Technical Service Information

FORD 4F50N 1-2 SLIDE / BANG

Figure 3

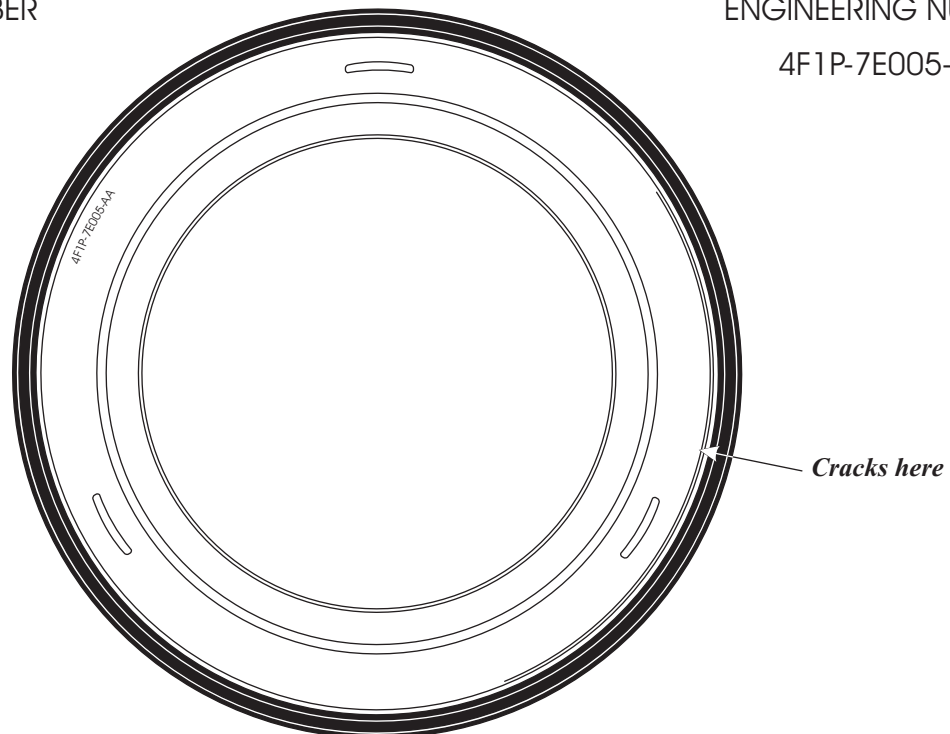
CAUSE: The cause may be, a cracked Intermediate Piston, as shown in Figure 3, or a weak 1-2 Capacity Modulator Valve Spring. Note: 2004 and Up 4F50N are equipped with the 1-2 Capacity Modulator Valve that controls the rate of application of the Intermediate Clutch, like the previous 1-2 Capacity Modulator Valve on the AXOD/AX4S. See Figure 4.

PREVIOUS DESIGN
ENGINEERING NUMBER
F88P-7E005-AA

NEW DESIGN
ENGINEERING NUMBER
4F1P-7E005-AA

CORRECTION: To correct this condition, replace the Intermediate piston with an updated piston from Ford or from your parts distributor as some distributors sell the O.E. pistons. Install a heavier spring into the 1-2 Capacity Modulator valve line-up. Note: the 2-3 Capacity Modulator Valve spring is the same as the 1-2 , if a firmer 2-3 upshift is desired , a firmer spring can be used there also. See Service information for available aftermarket replacement springs. *Note: the 1-2 and 2-3 Capacity Modulator Valve springs are identical so 2 aftermarket springs can be used, to cover 2nd and 3rd gear shift feel, per transmission overhaul.*

An updated piston can be identified by the engineering number printed on the bottom side of the piston as seen in figure 3. This number is slightly different than the part number.

Figure 4

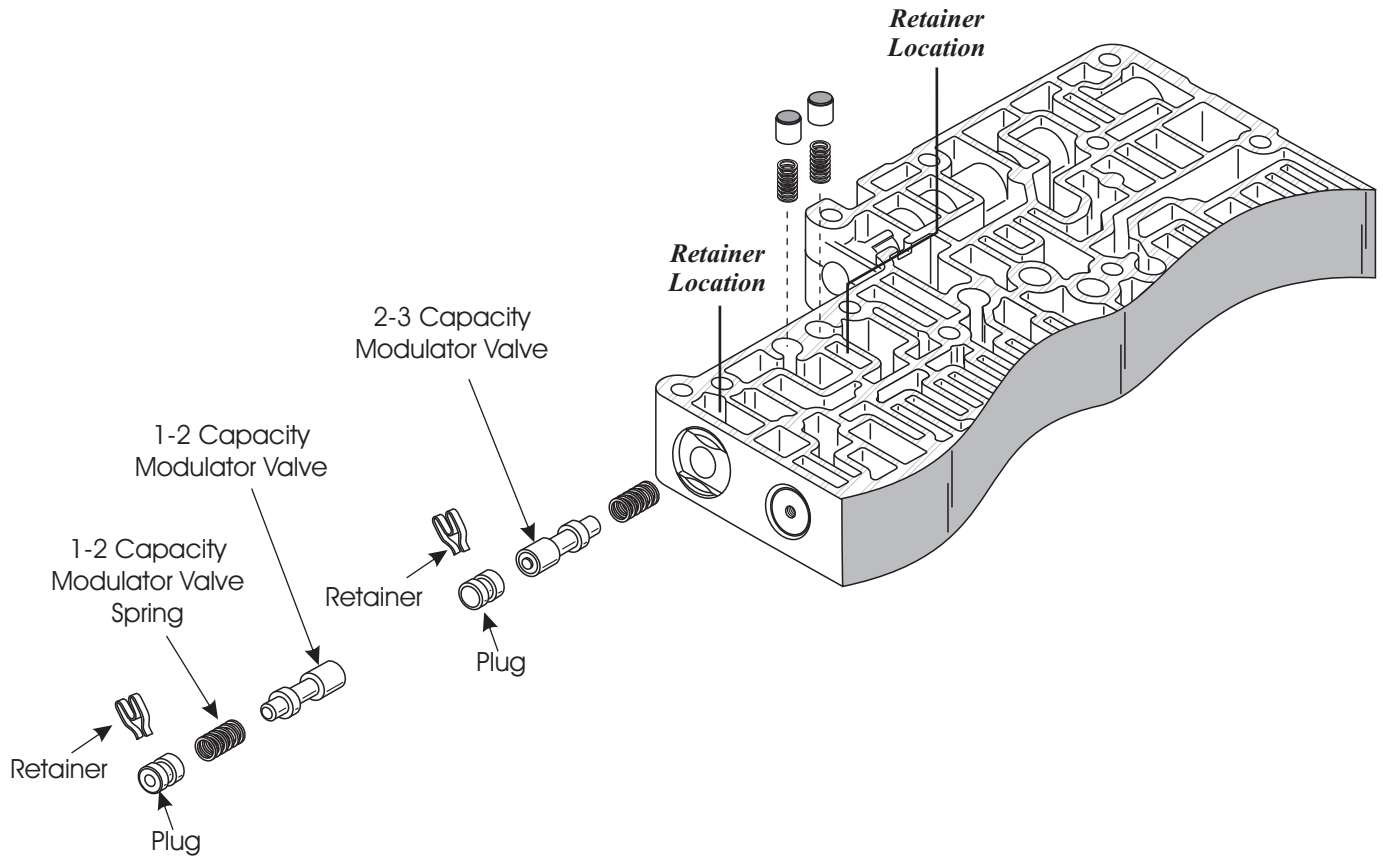
Note: The 1-2 and 2-3 Capacity Modulator valve springs are the same
